August 24, 2012
NRC3-12-0024

Subject: Detroit Edison Company Response to NRC Request for Additional Information Letter No. 78

Subject: Detroit Edison Company Response to NRC Request for Additional Information Letter No. 77

RAI Question No. 01.05-1

Figure 28: Comparison of hard rock UHRs in Fermi 3 FSAR (Updated EPRI-SOG model) with results computed using the CEUS SSC model.

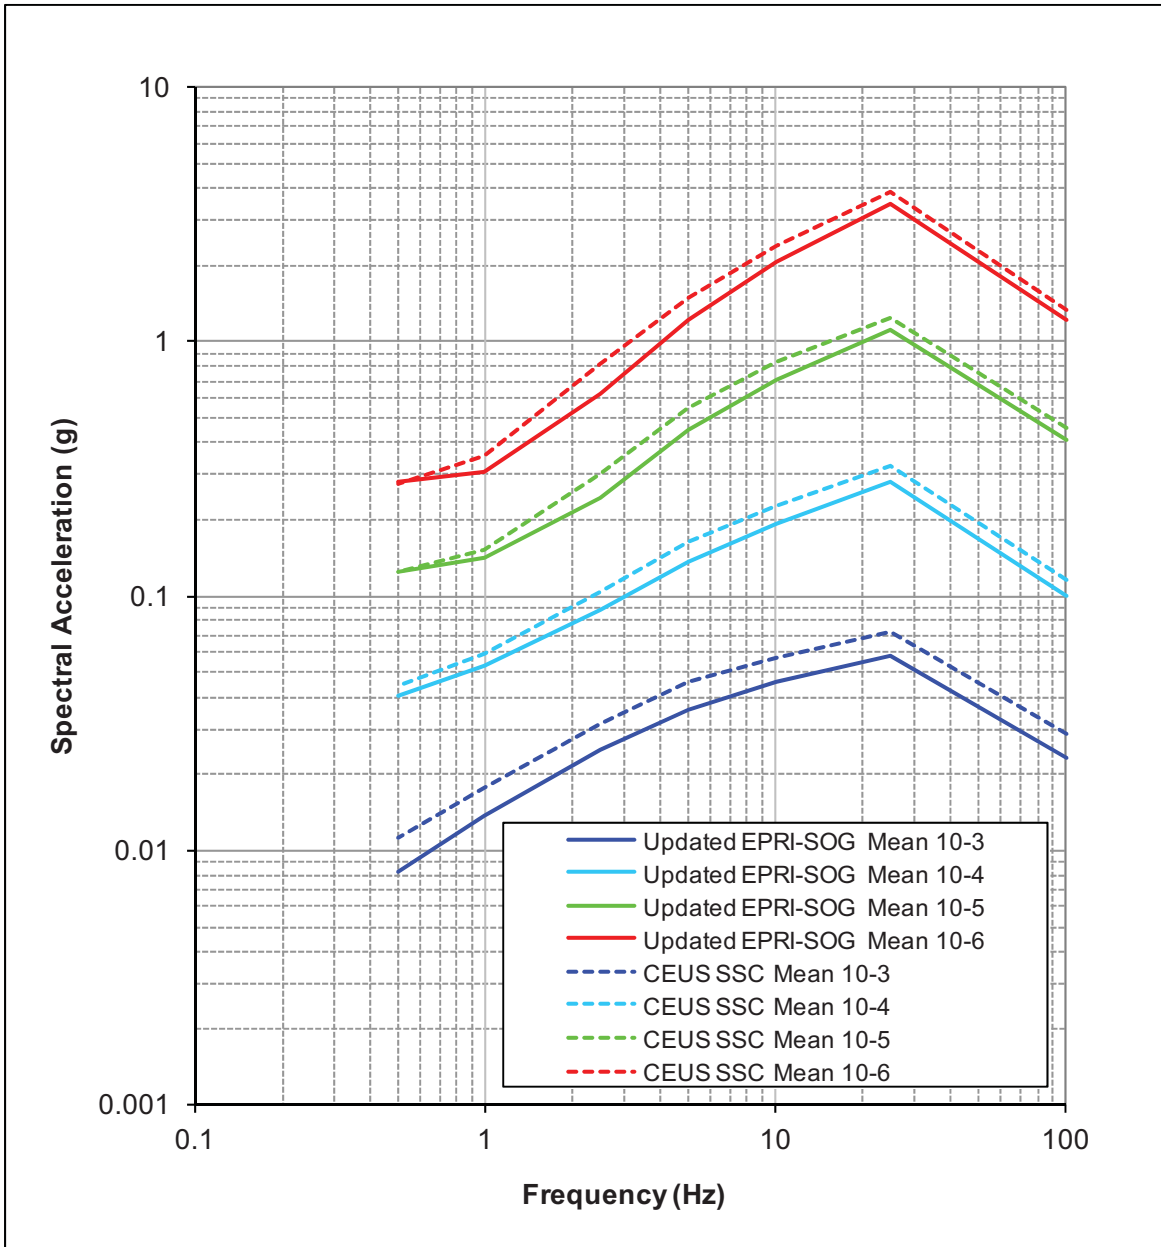
The mean hard rock hazard curves obtained using the CEUS SSC model are used to compute hard rock uniform hazard response spectra (UHRS). On Figure 28 and in Table 3, the CEUS SSC hard rock UHRS are compared with the results presented in Fermi 3 FSAR Subsection 2.5.2.4. The Fermi 3 hard rock UHRS based on the CEUS SSC model are generally higher than those based on the Updated EPRI-SOG model. This higher hazard from the CEUS SSC model is due primarily to changes in the characterization of the distributed seismicity sources.

Figure 29: Deaggregation of mean 10^{-3} hazard from CEUS SSC model.

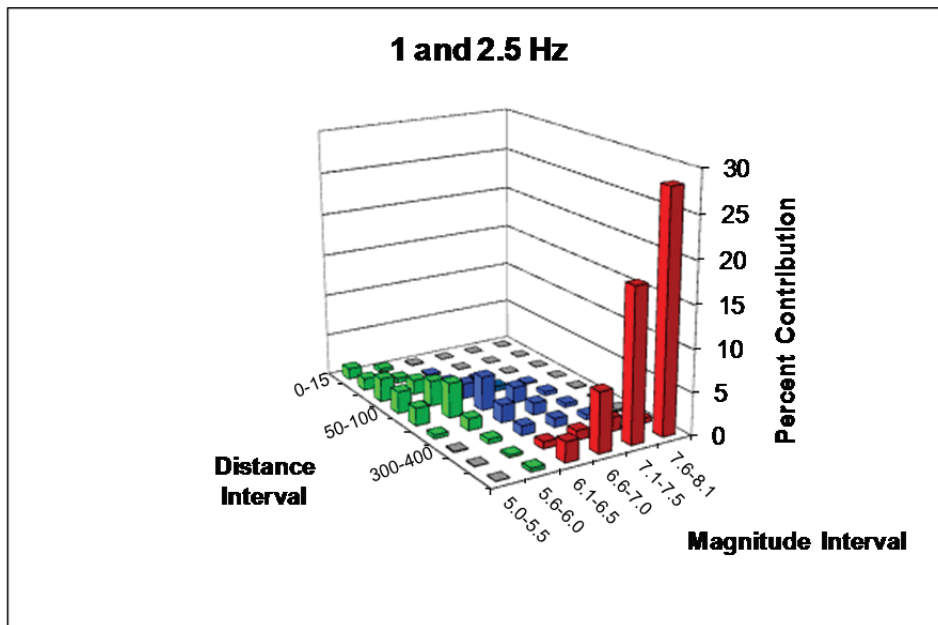
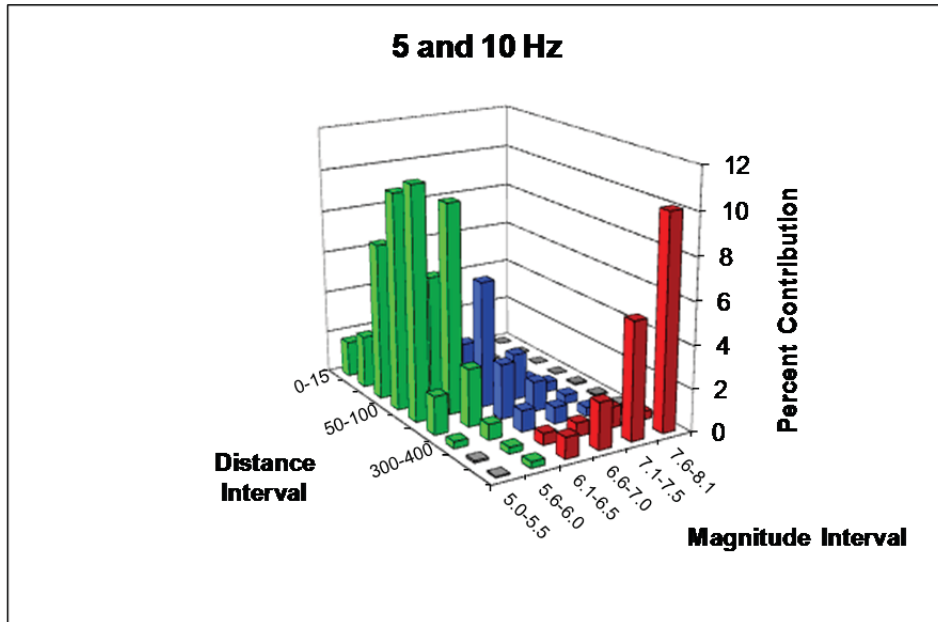
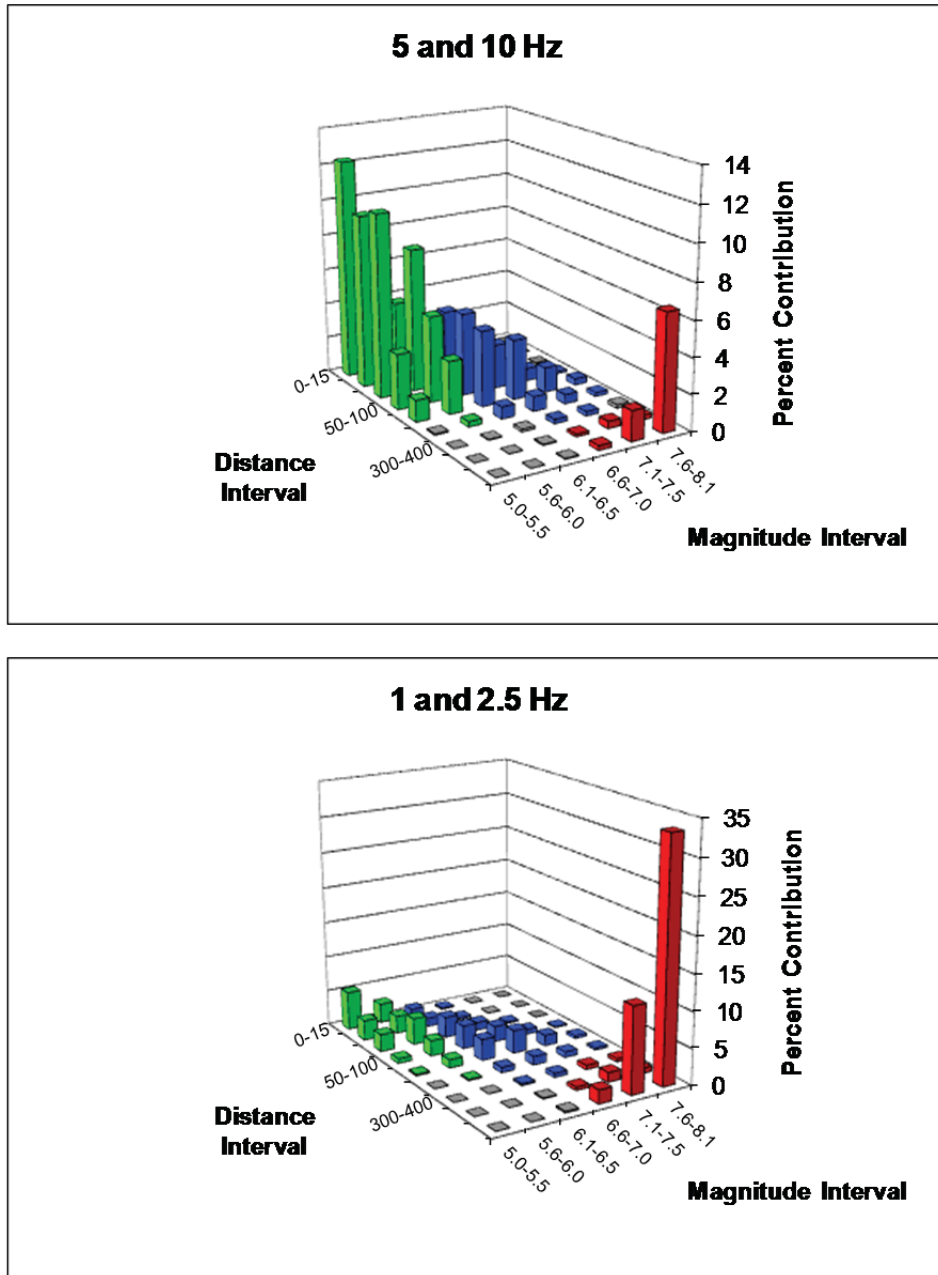
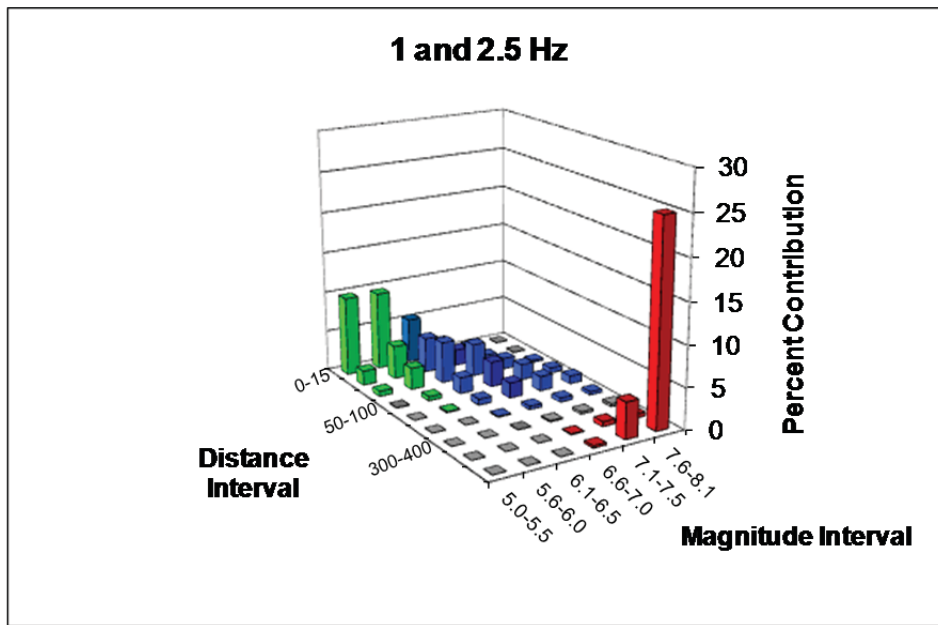
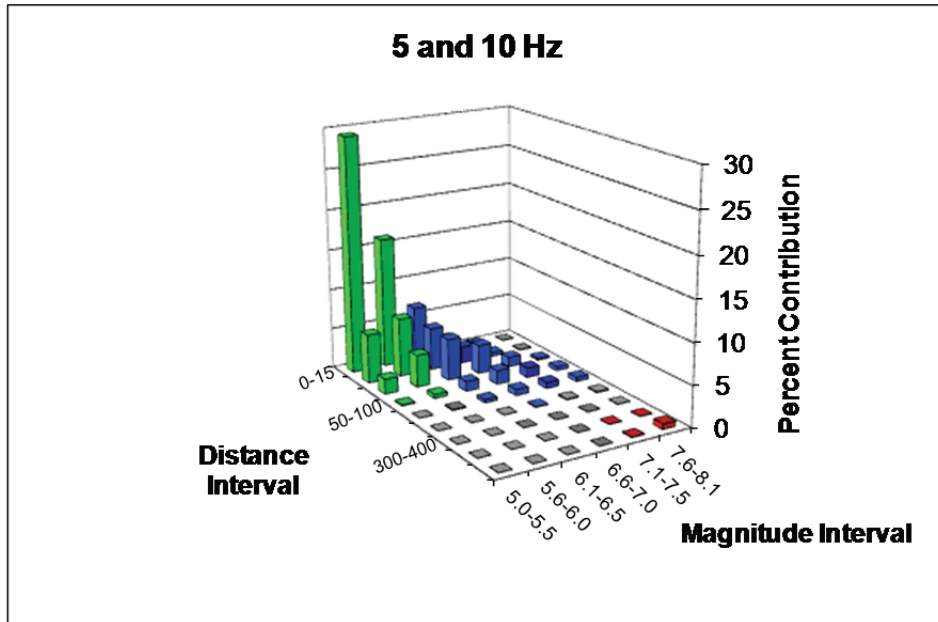
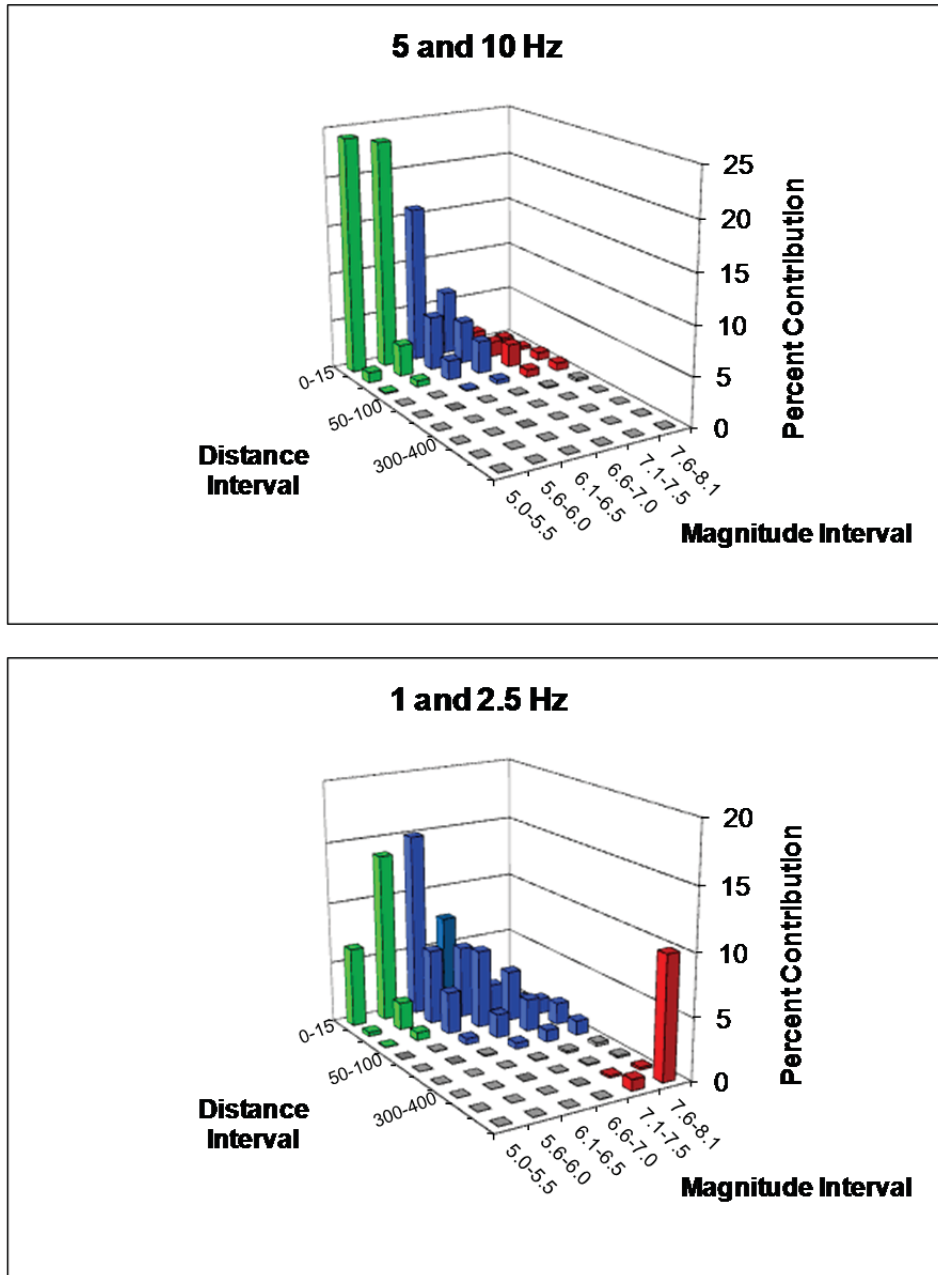
Figures 29, 30, 31, and 32 show the results from deaggregation of the CEUS SSC model mean hazard for exceedance frequencies of 10^{-3} , 10^{-4} , 10^{-5} , and 10^{-6} , respectively. These results were obtained following the procedure given in Appendix D of Regulatory Guide 1.208. Table 4 compares the magnitudes and distances for the reference (controlling) earthquake (RE) and the magnitudes, distances, and relative weights for the deaggregation earthquake (DE) developed from deaggregation of the CEUS SSC model mean hazard with the REs and DEs developed from deaggregation of the Updated EPRI-SOG model mean hazard (Fermi 3 FSAR Table 2.5.2-219). The deaggregation results from the two source models are generally similar. The magnitudes of the Updated EPRI-SOG model are given in terms of m_b while those for the CEUS SSC hazard results are given in terms of **M**. Thus, the magnitudes for the CEUS SSC model

The requested information is presented in Figures 29 through 32 of the response to RAI 01.05-1.

Figure 40: Comparison of UHRS at the GMRS elevation based on the Updated EPRI-SOG model with full CAV and the CEUS SSC model with modified CAV. Note that the 10^{-3} UHRS for the Updated EPRI-SOG model with full CAV is undefined and no spectrum is shown.

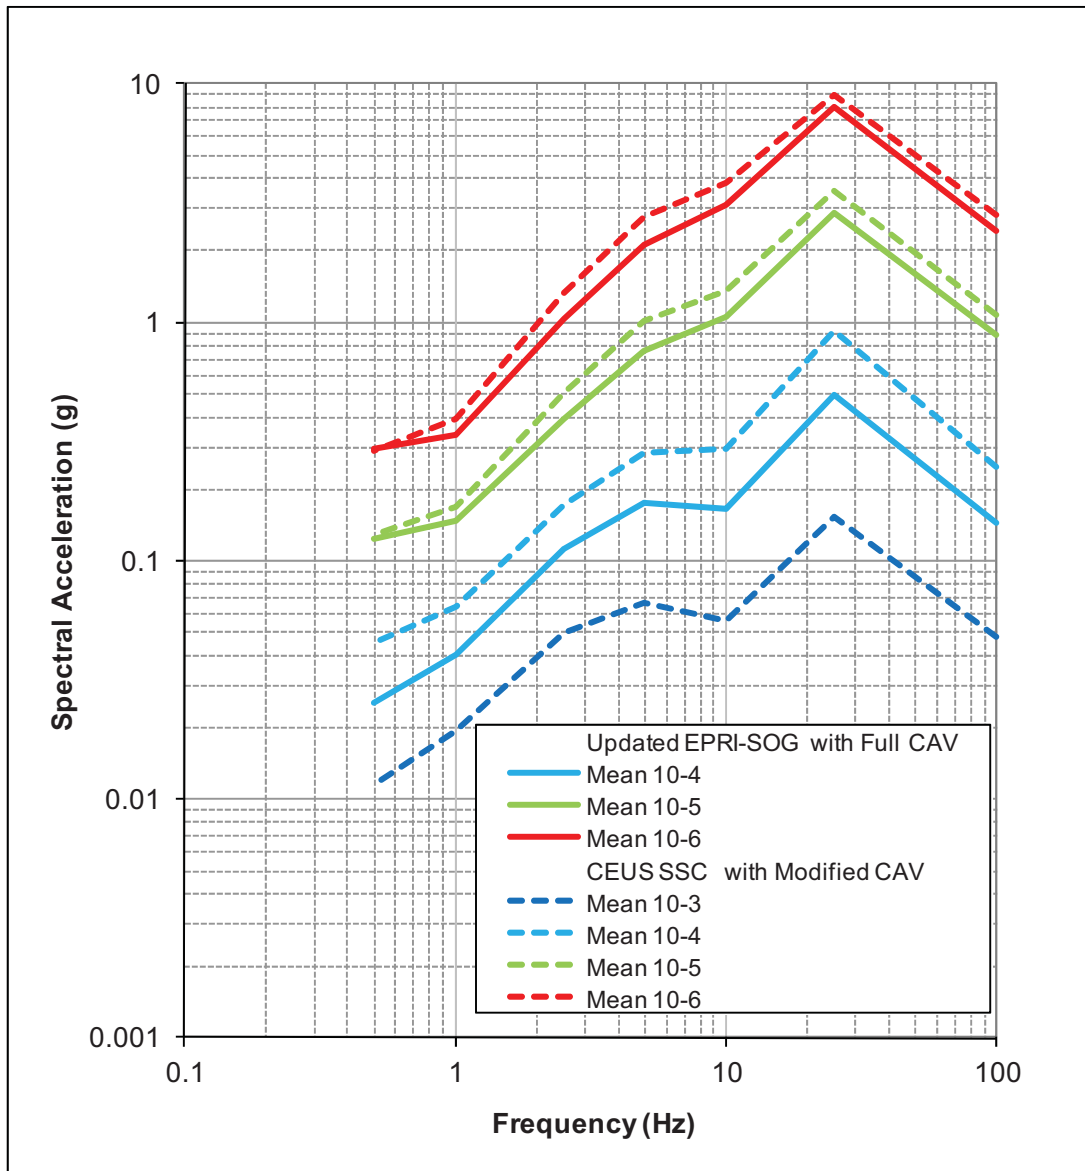
Figure 40 compares the UHRS for the GMRS elevation based on the CEUS SSC model with the modified CAV filter to the results based on the Updated EPRI-SOG model with the full CAV

filter. The UHRS amplitudes only show the seven computed spectral frequencies from the hazard calculations – 0.5 Hz, 1 Hz, 2.5 Hz, 5 Hz, 10 Hz, 25 Hz, and 100 Hz (PGA) – and have not been smoothed. The 10^{-3} UHRS for the Updated EPRI-SOG model with the full CAV filter was undefined; therefore, no spectrum is shown. The results show that the UHRS based on the CEUS SSC model and the modified CAV filter are higher than those based on the Updated EPRI-SOG model with the full CAV filter. The increase in amplitude for the 10^{-5} and 10^{-6} UHRS principally reflect increases in the hard rock hazard. The larger increase in the amplitude for the 10^{-4} UHRS includes the additional effects of the modified CAV filter.

Figure 41: Spectral shapes used to extend hard rock UHRS from 0.5 Hz to 0.1 Hz for the CEUS SSC model.

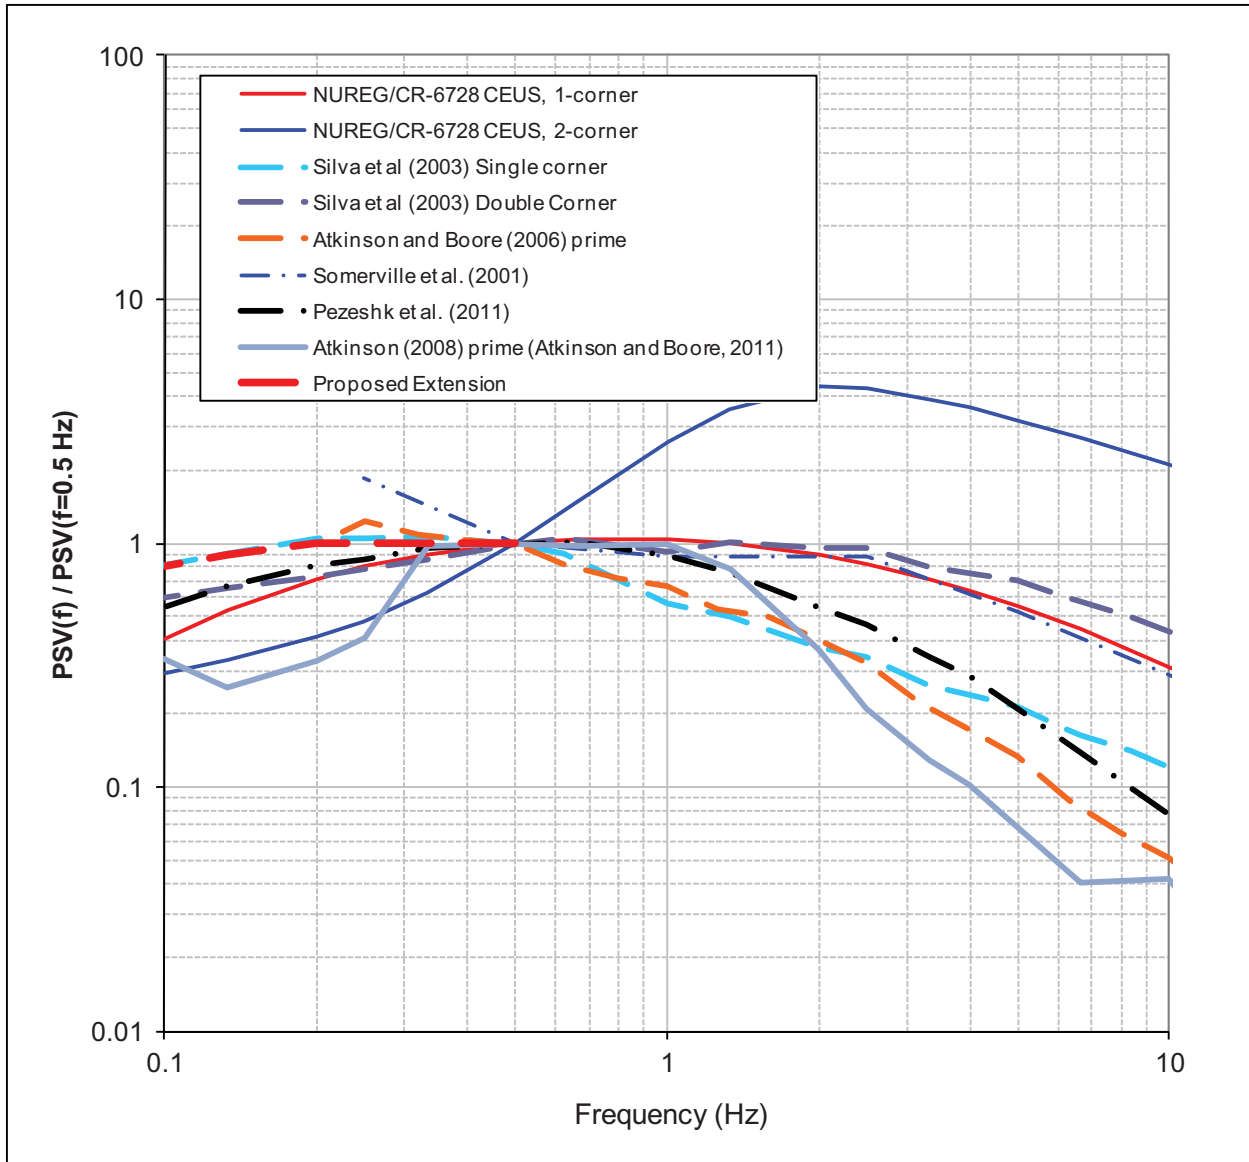
The heavy red dashed line in Figure 41 shows the low frequency extension from 0.5 to 0.1 Hz. The extension represents an envelope of the spectral shapes consistent with the mean magnitude and distance from the deaggregation of the 0.5 Hz hazard results based on the CEUS SSC model. The extension defines constant spectral velocity from 0.5 to 0.2 Hz, followed by a small decrease from constant spectral velocity extending from 0.2 to 0.1 Hz. The spectral amplitude at 0.133 Hz (7.5 seconds spectral period) is 90 percent of what it would be for a constant spectral velocity value and the spectral amplitude at 0.1 Hz is 80 percent of the constant spectral velocity value. This extension is used to produce the low-frequency hard rock UHRS to which the site amplification functions are applied.

The low frequency extension reflects both the difference between the mean magnitudes and distances of the CEUS SSC model and the Updated EPRI-SOG model, which reduces the 0.1 Hz spectral velocity value, and recent ground motion models that contain estimates of 0.1 Hz motions that result in lower relative motions at 0.1 Hz than would be obtained assuming constant spectral velocity from 0.5 to 0.1 Hz. The change from constant spectral velocity at frequencies below 0.2 Hz is consistent with the response spectrum approaching constant displacement. Equation (21) of Abrahamson and Silva (Fermi 3 FSAR Reference 2.5.2-275) suggests that the spectra for **M** 7.5 earthquakes should reach constant displacement at a period of 10 seconds (frequency of 0.1 Hz). The spectral shape in the frequency range between 0.1

and 0.2 Hz shown on Figure 41 represents this transition from constant velocity to constant displacement.
